OICA proposal for amendments to GRE/2013/3 (Regulation No. 10)

The text reproduced below was prepared by the expert from OICA, in order to amend document GRE/2013/3, extending the scope of Regulation No. 10 to all kinds of power train systems above a certain working voltage level, when they are in charging mode. The modifications are marked in bold for new or strikethrough for deleted characters.

Figure 1: HV artificial network

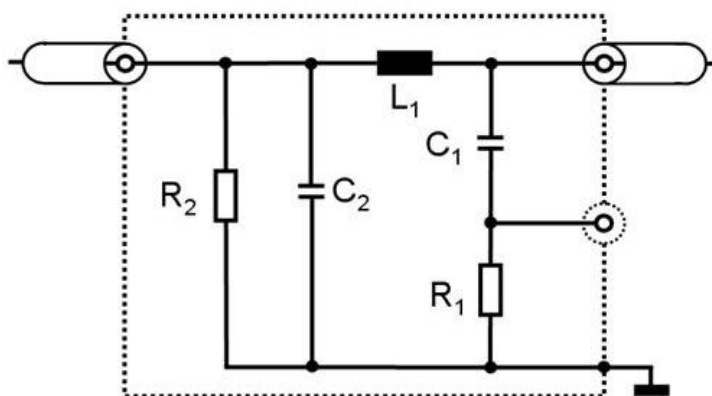
Appendix 8, figure 1, HV artificial network, R2 value, amend to read:

<i>Key</i>	<i>C₂: 0.1 μF</i>
<i>L₁: 5 μH</i>	<i>R₁: 1 kΩ</i>
<i>C₁: 0.1 μF</i>	<i>R₂: 1 MΩ 100 kΩ (discharging C₂ to < 50 V_{dc} within 60 s)</i>

2. Appendix 8: The value of Resistor R_2 shall be increased from 100 k Ω to 1 M Ω because, if the value of this resistor is too low, the isolation protection circuit of a tested high voltage device could be activated and switch off the high voltage system under test.

Generally, REESS HV line isolated to the ground or vehicle body by 1M ohm or more to reduce the touch current. R_2 : 100k ohm in HVAN (High Voltage Artificial Network) will cause some leakage of current from HV lines. A certain level of leakage current will activate the fail-safe function which shut down the HV lines between REESS and HV power module. R_2 : resistance to the ground earth should apply 1M ohm which is equivalent value to insulation resistance of HV lines of REESS. This HVAN is applied in ESA immunity function test. To confirm the immunity performance in ESA, HVAN should keep the equivalent insulation resistance condition to vehicle test.

Figure 2: Impedance of HV artificial network

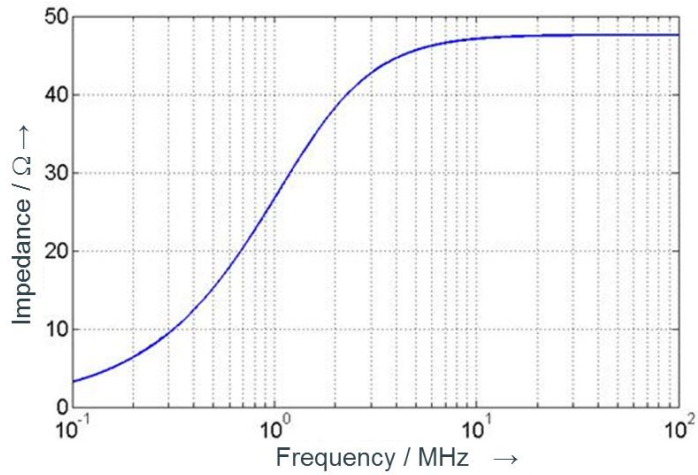
Appendix 8, figure 2, delete and replace by:

3. Appendix 8, figure 2, HV artificial network: editorial correction, from German to English nomenclature

"4.4. Measurements

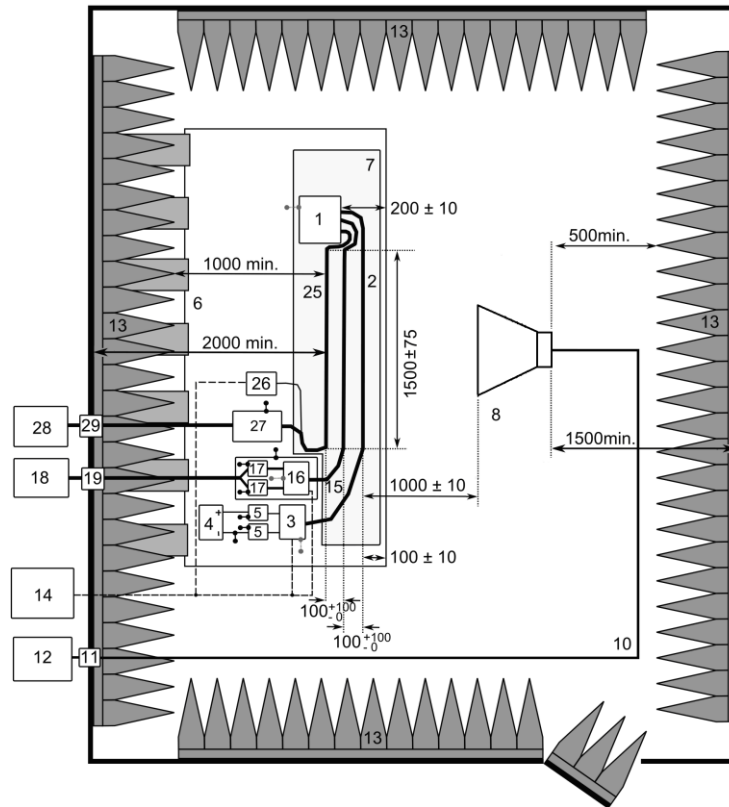
Annex 7, para. 4.4., amend to read:

Unless otherwise specified the configuration with the LV harness closer to the antenna shall be tested.

The phase centre of the antenna shall be in line with the centre of the longitudinal part of the wiring harnesses for frequencies up to 1'000 MHz.

~~The phase centre of the antenna for frequencies above 1'000 MHz shall be in line with the ESA.~~

8. Annex 7, para. 4.4.: editorial correction; an unnecessary sentence was deleted. Test frequency is below the 1000MHz.
 9. Annex 9, Appendix 3: Figure had to be improved because vertical polarization is applied in this regulation. Vertical layout figure should thus be applied in this annex. In vertical layout figures, horn antenna figure will be better and easier to recognize the antenna polarization compared with bi-conical antenna in figures.

Figure 1

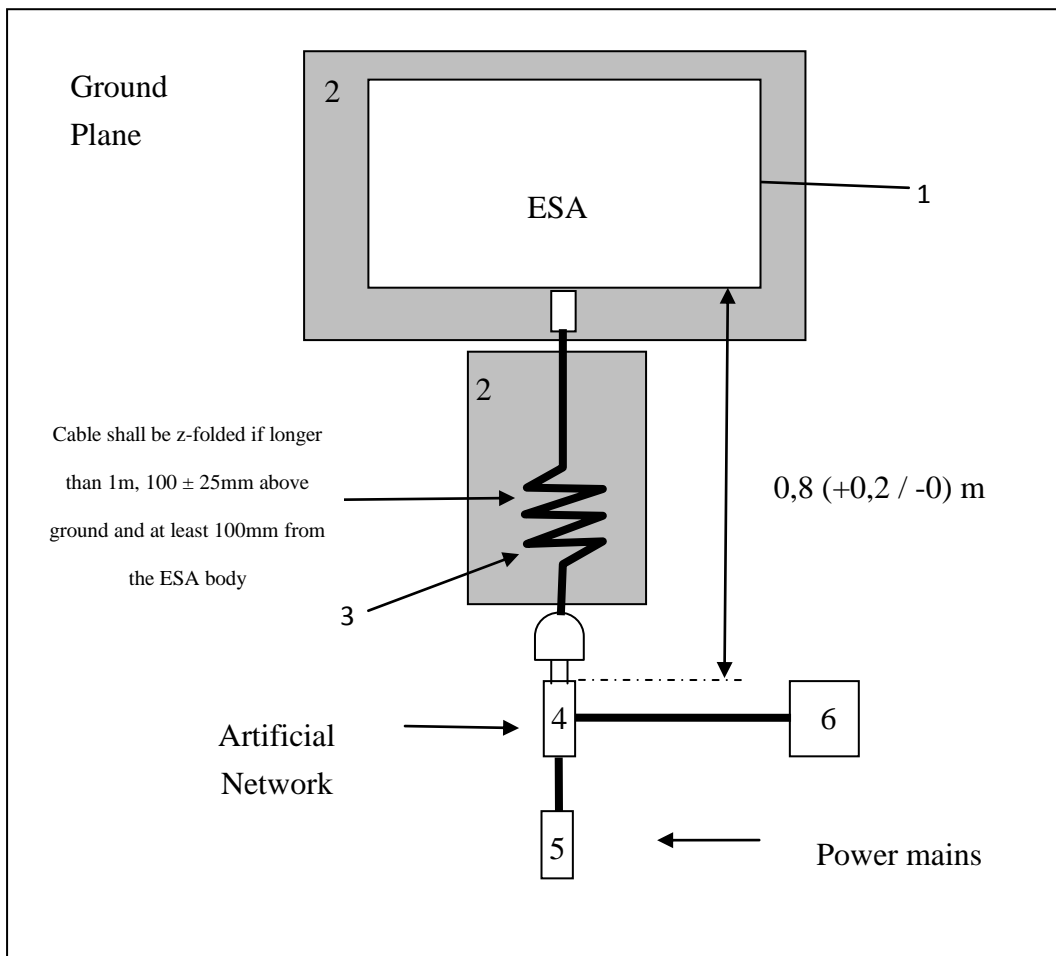
Annex 19, Appendix 1, Figure 1, delete and replace by:

ESA in configuration "REESS charging mode coupled to the power grid"

Figure 1: ESA in configuration "REESS charging mode coupled to the power grid" – Coupling between lines for DC or AC (single phase) power lines.

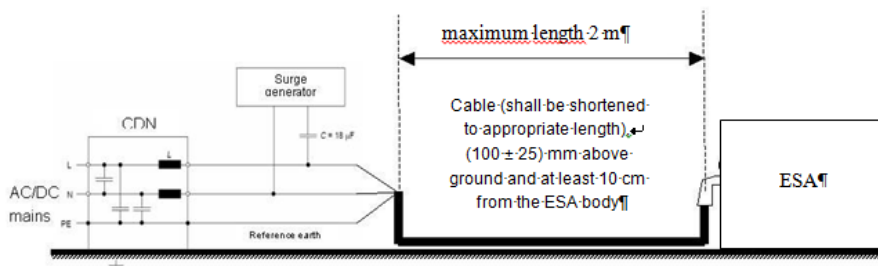
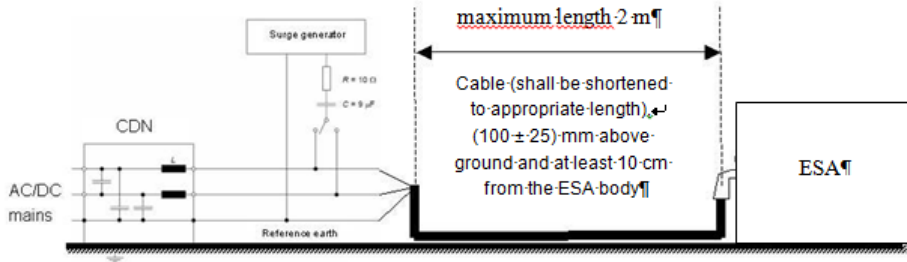
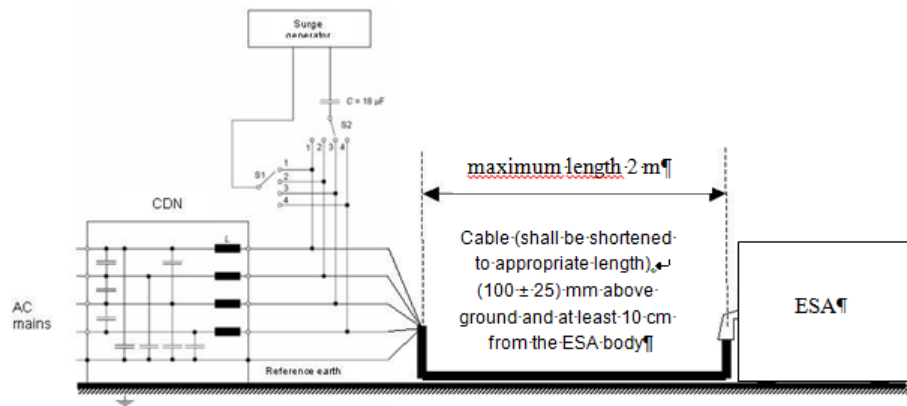
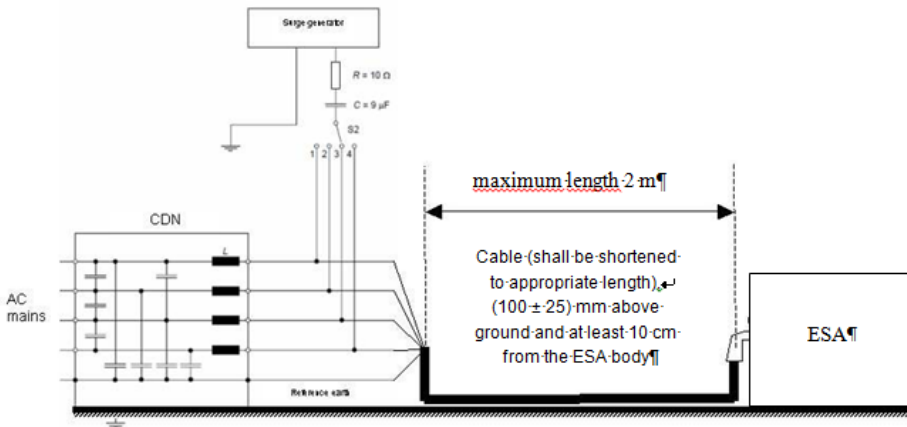
Annex 22, Appendix 1, Figures 1-4, deleted and replace by:
